COLLIN COUNTY
JUSTICE
CENTER

JUSTICE CENTER DOMESTIC WATER LINE REPLACEMENT
McKinney, Texas

PC0 2-1 After Change Order, Example A

LOWER LEVEL MECHANICAL ROOM

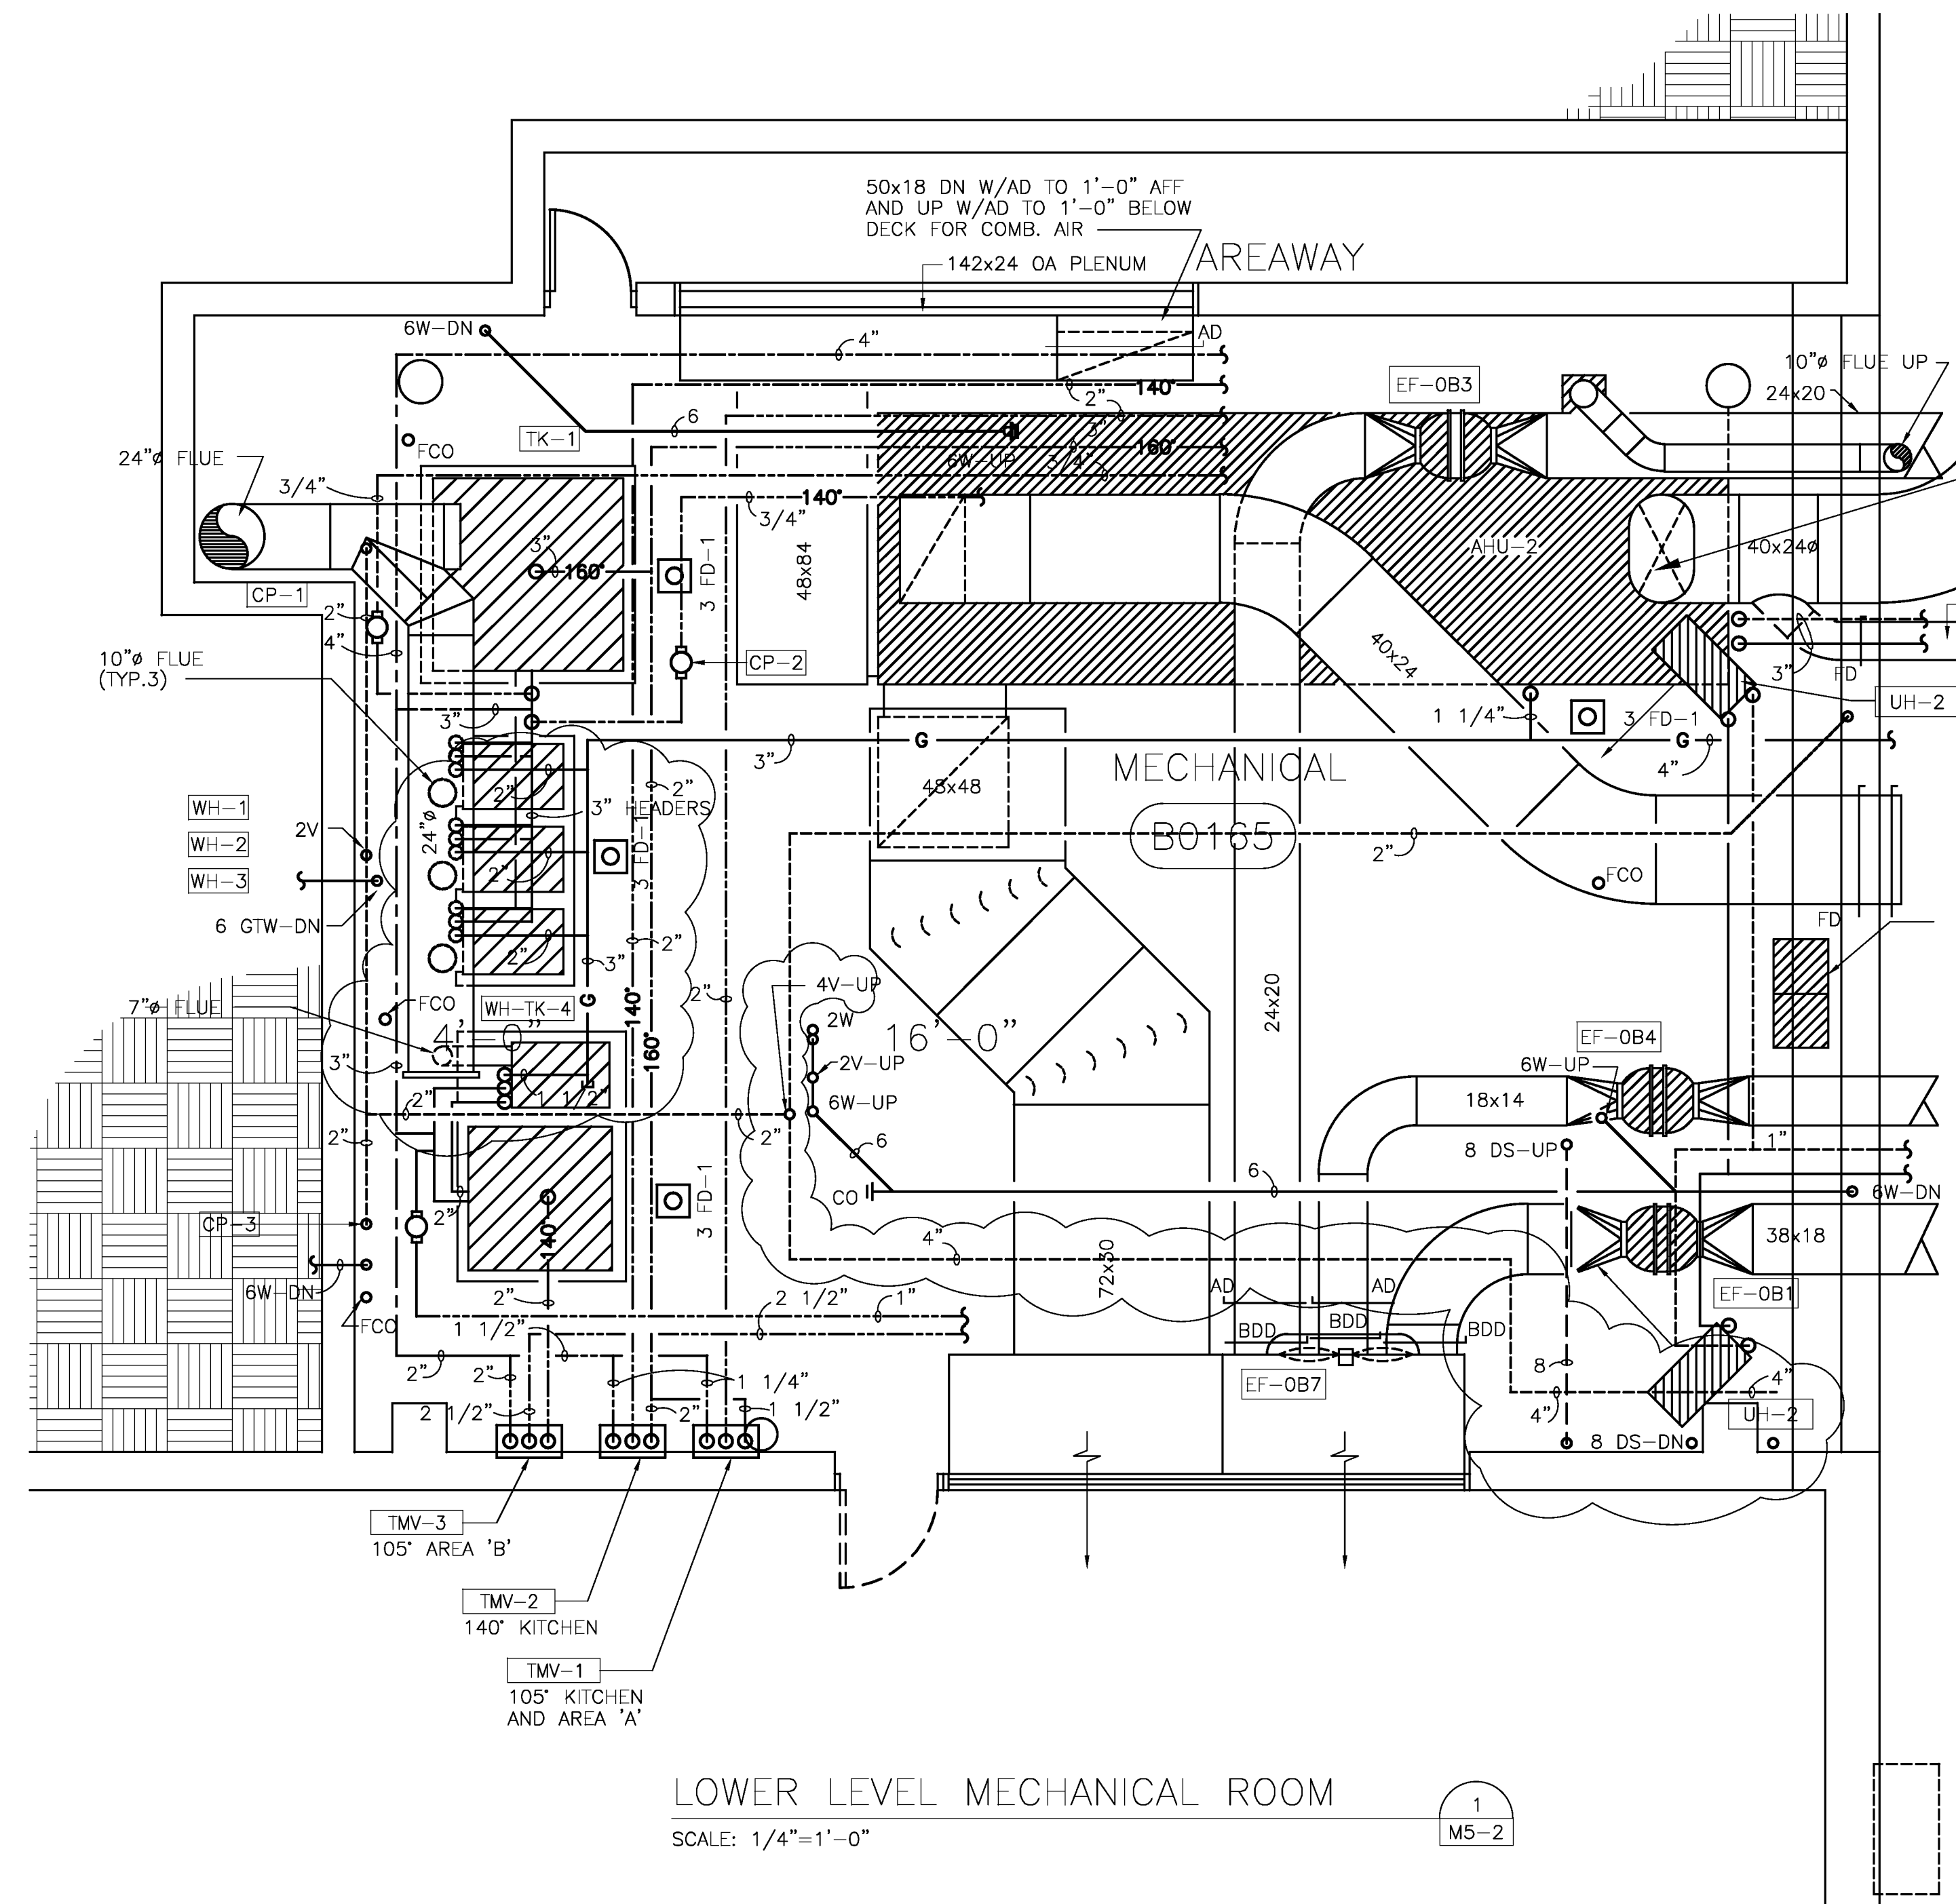
XX RFI #428
XXX AHU Will be a
(6) 2'X2'X5 1/4"
Concrete
Pads

PC0 2-1 After Change Order, Example B

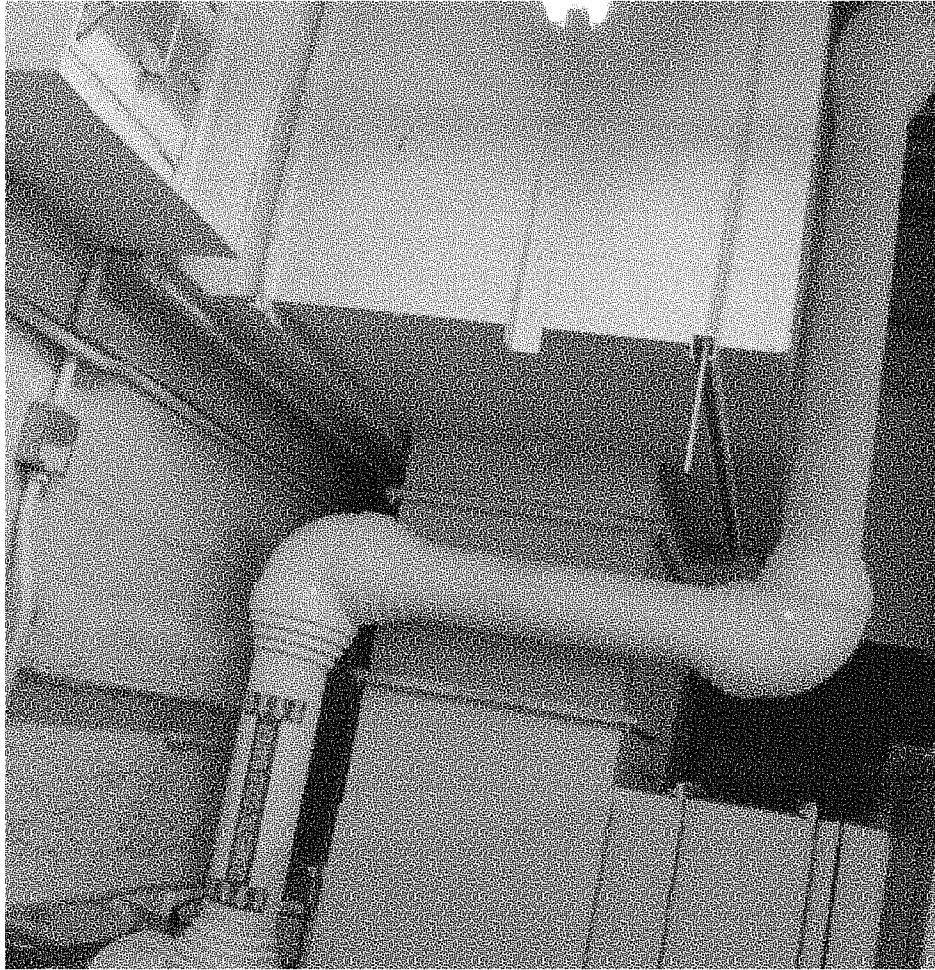
PC0 2-1 After Change Order, Example B

PC0 2-1 After Change Order, Example B

PC0 2-1 After Change Order, Example F

PC0 7-5 TEE Between Backflow Preventors

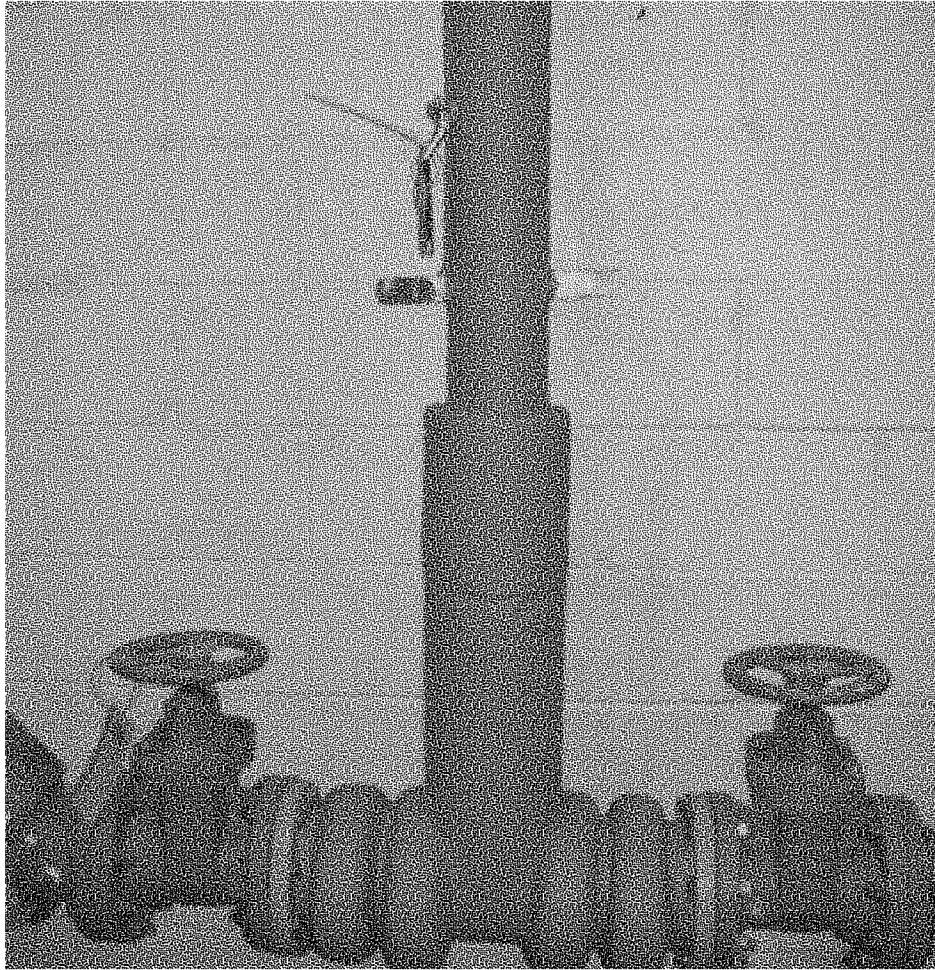
Branch Connection Missing
